Re: Alofts Project, Phoenix, AZ – 2-Hour Sure-Board® Wall Assemblies

Re: Alofts Project, Phoenix, AZ - 2-Hour Sure-Board® Wall Assemblies

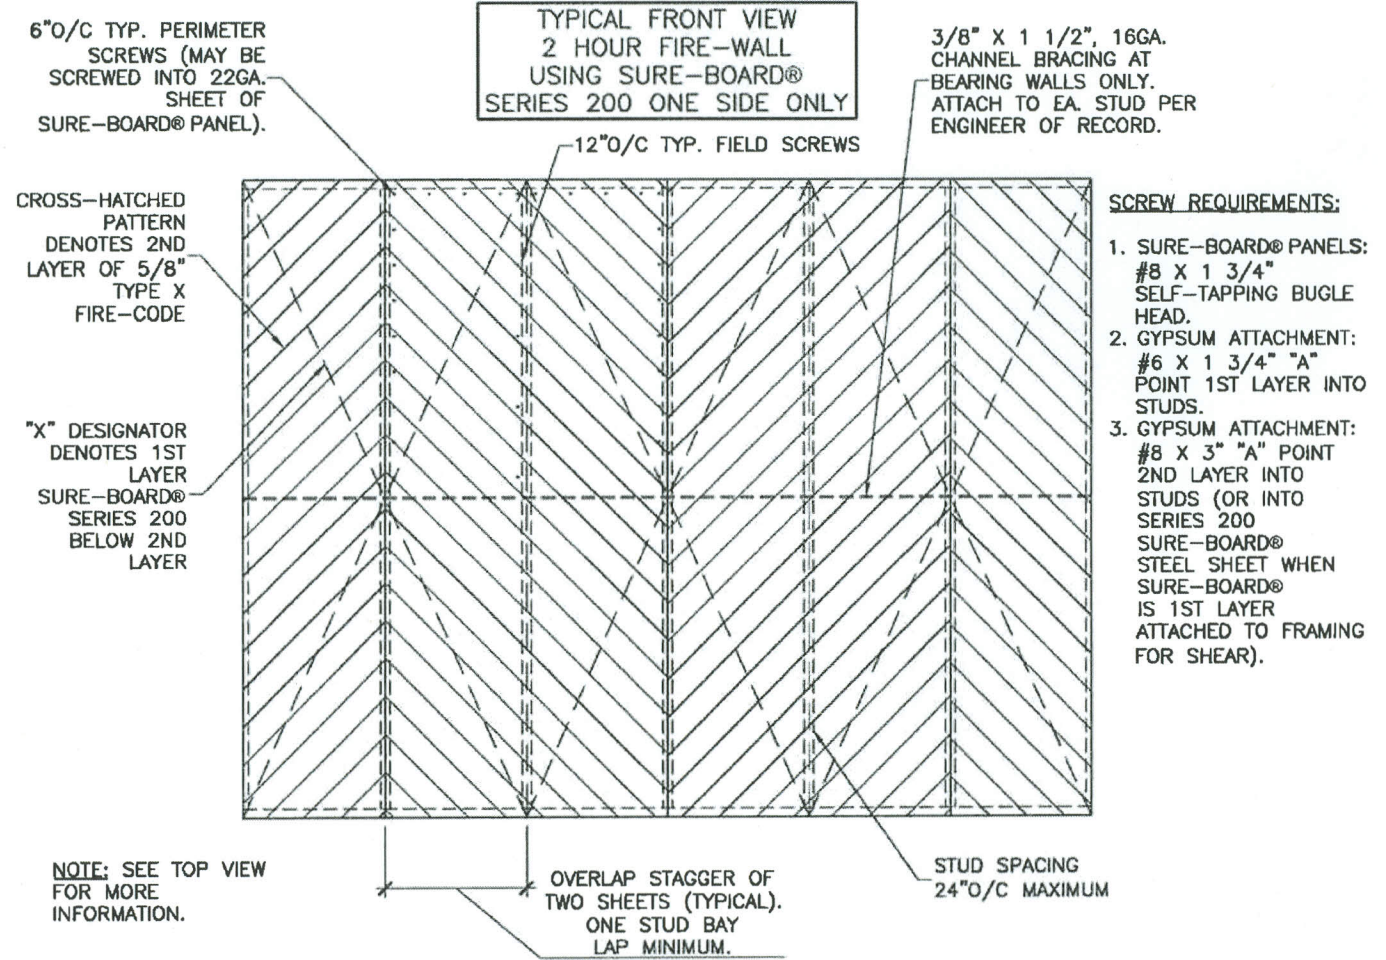
Intertek has reviewed the enclosed wall assembly designs and confirm that the addition of Sure-Board® Series 200 as described will not affect the original 2-hour fire resistance rating of the assembly.
